TOWN OF COTTESLOE

UNCONFIRMED MINUTES

4:00pm Thursday, 11 February 2021

8.1.1 COTTESLOE FORESHORE REDEVELOPMENT PROJECT - TOILET BLOCK CONCEPT

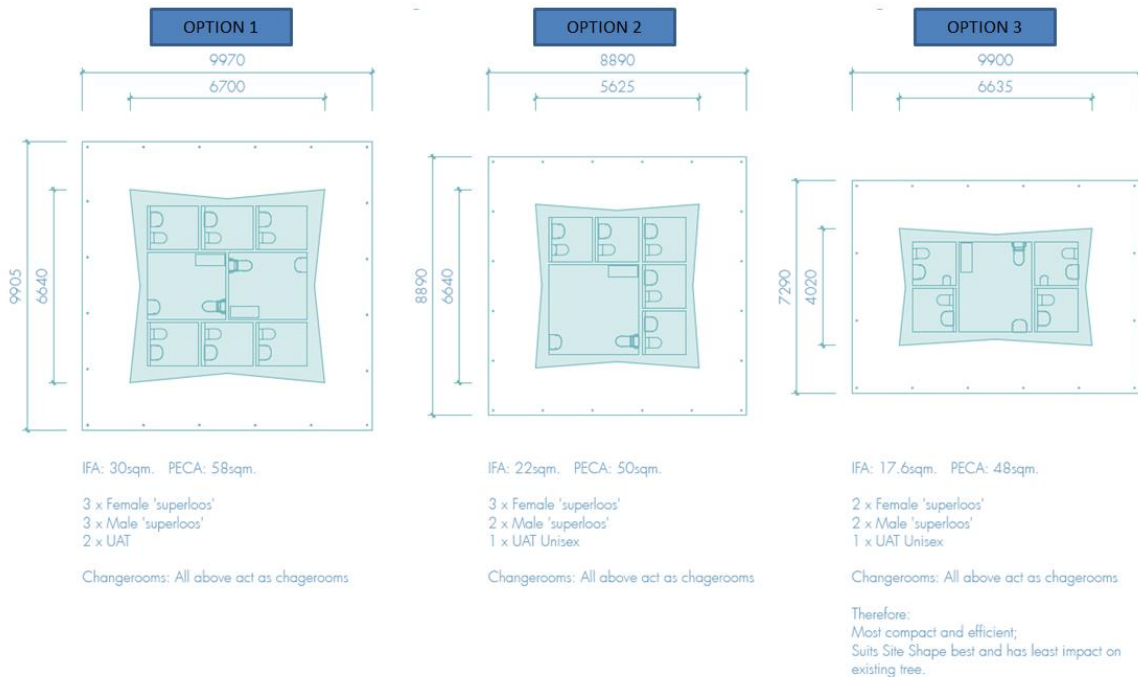
As shown on the enclosed document and indicated with an 'X' on the diagram below, an area immediately to the north of the parking plaza has been marked for the construction of a toilet facility. This would provide the required amenity for the vicinity and particularly for visitors to the playground as the next available facility is a fair distance away either at the Indiana Teahouse to the south or Barchetta in North Cottesloe.

THAT the Foreshore Precinct Advisory Committee recommends the matter be laid on the table for approximately. Two weeks for Aspect Studios to consider the following points based on option 3;

1. **Incorporate greater visual permeability and consider sculptural elements (lantern)**
2. **Integrate the toilet block with other elements of the foreshore design**
3. **Aspects to present an artist impression of the area**
